# Return acknowledgement modification of MicroVent

*modification kit 8413122 according to IDM 11/95 Nr. 1 in the following unit.*

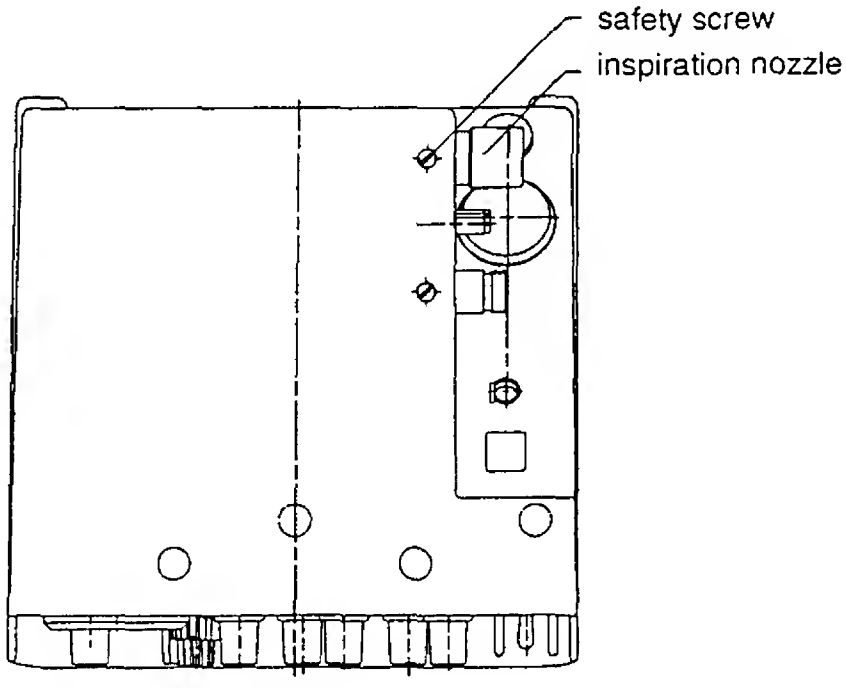
1.) Remove safety screw of inspiration nozzle

2.) Pull inspiration nozzle from the side

3.) Slide the new nozzle 84 13 119 far enough in so that from above it can be lined up with the safety screw which should be screwed back into its former position.
